Product / Process Change Notification (PCN)							
<input checked="" type="checkbox"/> Major Change <input type="checkbox"/> Minor Change							
PCN Number: PCN_WPME-FISM_1779205311_20250120 Affected Series: WPME-FISM Affected Part Number: 1779205311 PCN Date: 2024-12-20 (YYYY-MM-DD) Effective Date: 2025-01-20 (YYYY-MM-DD)	Change Category: <input checked="" type="checkbox"/> Equipment/Location <input checked="" type="checkbox"/> General Data <input checked="" type="checkbox"/> Material <input type="checkbox"/> Process <input checked="" type="checkbox"/> Product Design <input checked="" type="checkbox"/> Shipping/Packaging <input checked="" type="checkbox"/> Supplier <input type="checkbox"/> Software						
Contact: Product Management Phone: +49 (0) 7942 - 945 5001 Fax: +49 (0) 7942 - 945 5179 E-Mail: pcn.eisos@we-online.com	Datasheet Change: <input checked="" type="checkbox"/> Yes <input type="checkbox"/> No Attachment: <input checked="" type="checkbox"/> Yes <input type="checkbox"/> No						
DESCRIPTION OF CHANGE: <p>Due to an improvement of the production capability, Würth Elektronik eiSos has shifted the production of the affected part number to a new factory location.</p> <p>Wit

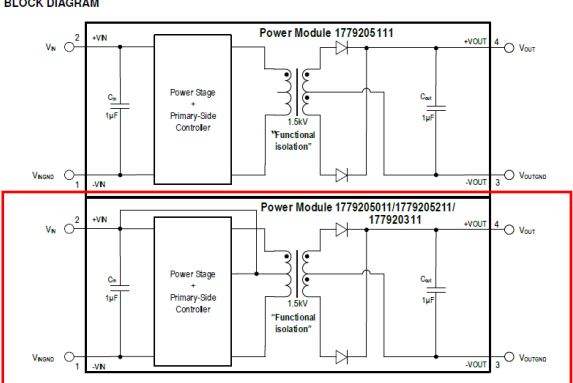
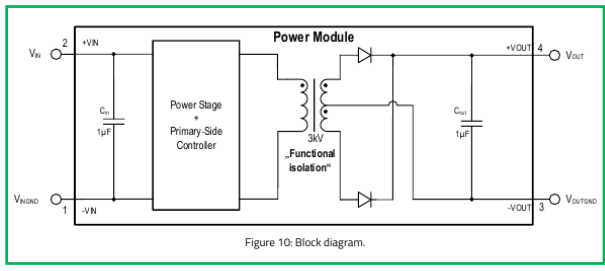
The datasheet MTBF specifications have been adjusted based on the new internal design.

19.1 Soldering Profile

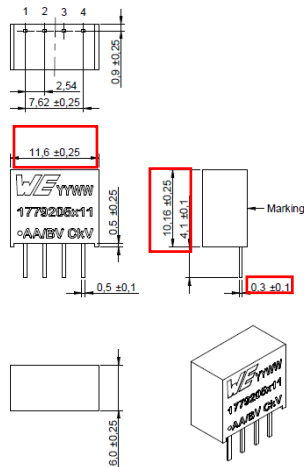
The handling recommendations for the wave solder profile have been expanded to include the maximum allowable time for each wave.

Profile Feature	Old standard (Pb)	New (Pb-free)
Time within peak temperature t_p	max. 10s max. 5s each wave	max. 10s max. 5s each wave
Average ramp-up rate	200°C/s	200°C/s
Final preheat temperature T_s	130°C/s	130°C/s
Peak temperature T_p	+235°C/s	+260°C/s
Ramp-down rate	-5°C/s	-5°C/s
Heating rate during preheat	4°C/s	4°C/s

PHYSICAL DIMENSIONS

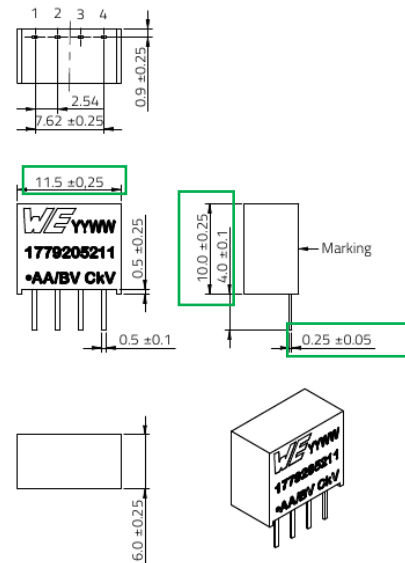
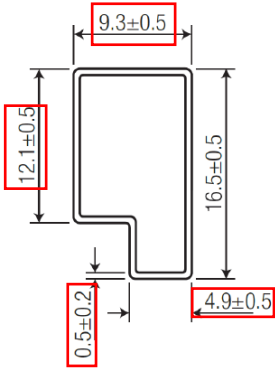
The mechanical dimensions have been updated based on new production. SIP-4 package shapes stay the same but with slightly deviated package length and height. Production tolerances have been changed based on new production line.
